Our ref: PS118400-P&M-LTR-011 Request for Additional Info

Health Infrastructure engaged WSP to prepare a Transport Assessment (TA) as part of an Environmental Impact Statement (EIS) for inclusion in a State Significant Development Application (SSDA) for the Children's Hospital at Westmead Redevelopment Stage 2, Paediatric Services Building. The TA (March 2021) assessed the traffic, car parking and loading requirements of the proposal.

RESPONSE TO SUBMISSIONS – TRAFFIC AND TRANSPORT

ATTACHMENT E
CMRI AND FORECOURT
DRIVEWAY SWEPT PATHS

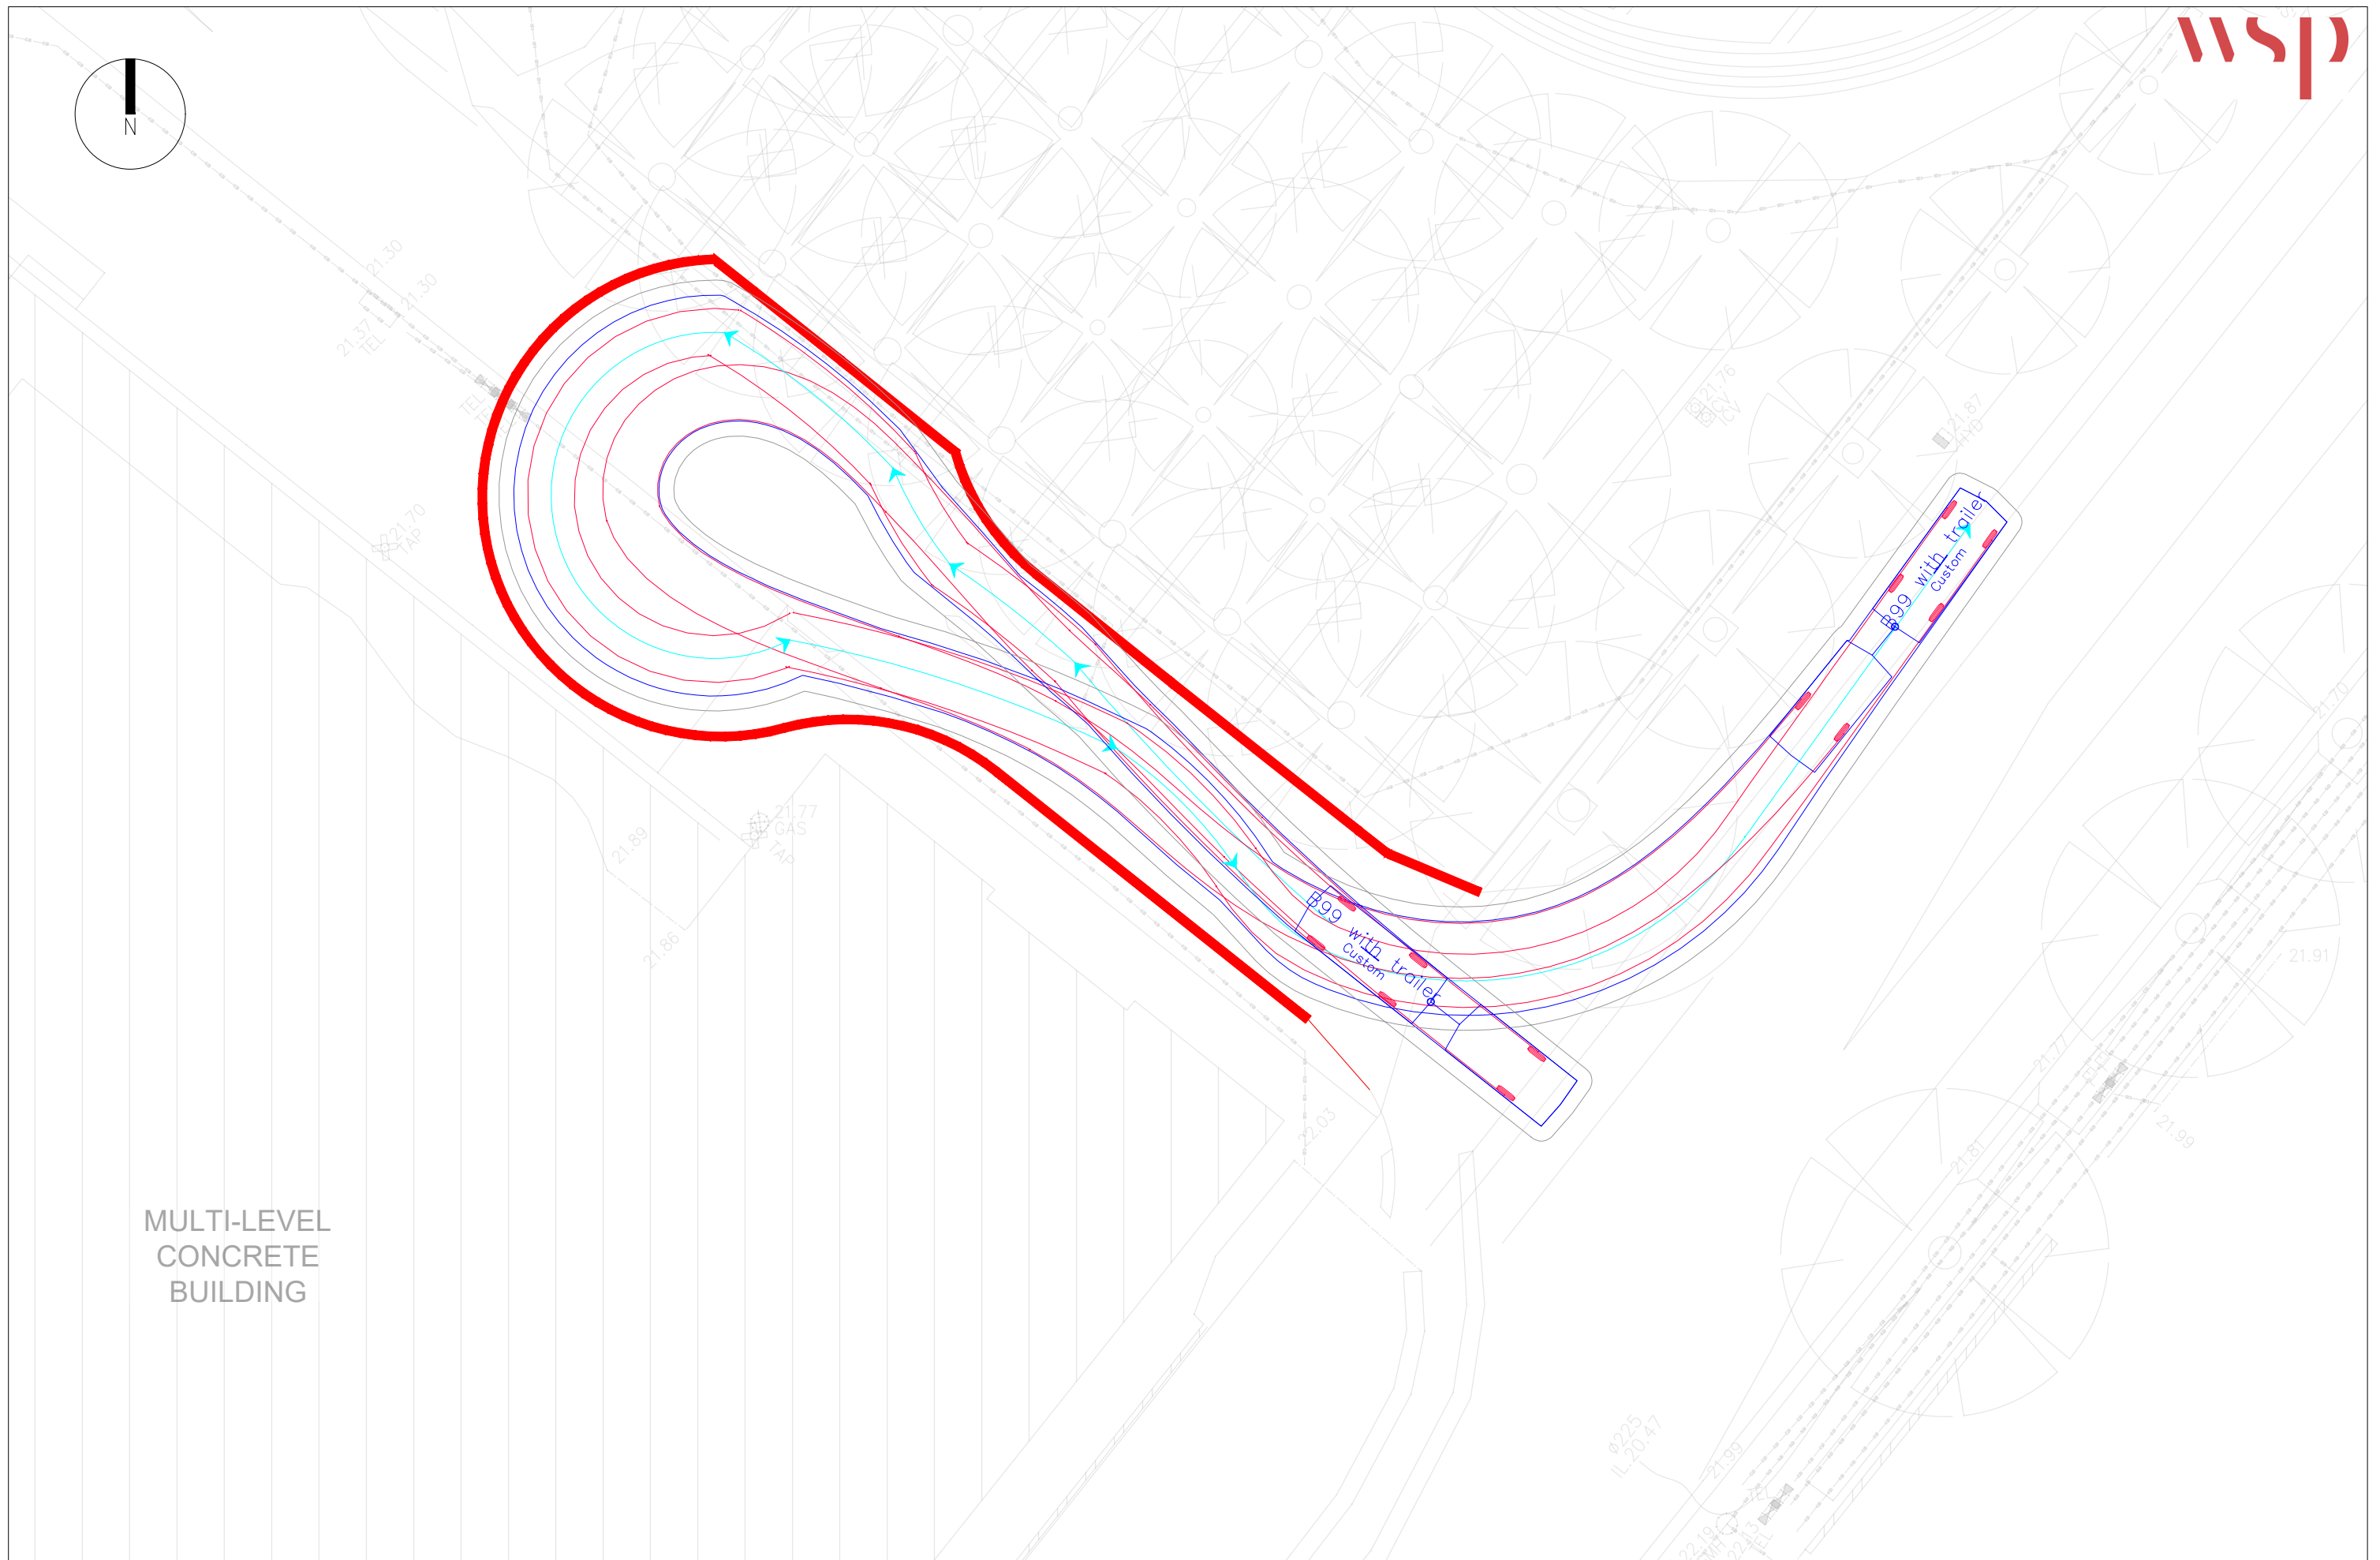
Swept path plans for loading vehicles (i.e. a B99 vehicle with trailer, 8.8m service vehicle and a 12.5m HRV) accessing the driveway into the Children's Medical Research Institute was provided. Loading vehicles accessing this driveway will obstruct two-way traffic flow as the swept paths demonstrate all loading vehicles occupying most of the driveway width when undertaking manoeuvres. A B99 vehicle with trailer and 8.8m service vehicle crosses to the other side of the driveway to undertake u-turn manoeuvres at the cul-de-sac and the 12.5m HRV truck occupies the whole driveway width on entry. Furthermore, the 12.5m HRV truck reverses out onto Hawkesbury Road which can be a safety hazard for pedestrians and oncoming vehicles. It is noted that access for 12.5m HRV truck is only required in the event of a catastrophic failure of the CMRI generator. Some of the access concerns can be addressed using a LDMP and widening of the driveway width (see above for further details).

It is noted that the plans submitted (Dwg No. CHW-AR-DG-PSB-SSD011 Rev E) appears to show a concrete median proposed close to the cul-de-sac at the end of the driveway. It is recommended that the concrete median be removed to facilitate loading manoeuvres.

- A Loading Dock Management Plan for PSB building would be developed as part of the condition of the Construction Certificate.
- A Loading Dock Management Plan for the KidsPark would also be developed as part of the condition of the Construction Certificate. It is intended that deliveries to the retail pods in KidsPark would be undertaken outside of the core operating hours of businesses in the Westmead Health Precinct. Delivery vehicles to the retail pod would also be able to park within KidsPark as shown in Attachment B.

- The existing intersection of Hawkesbury Road with the service road north-east of CMRI will be retained. There will be infrequent traffic entering/exiting the service road as it would only provide:
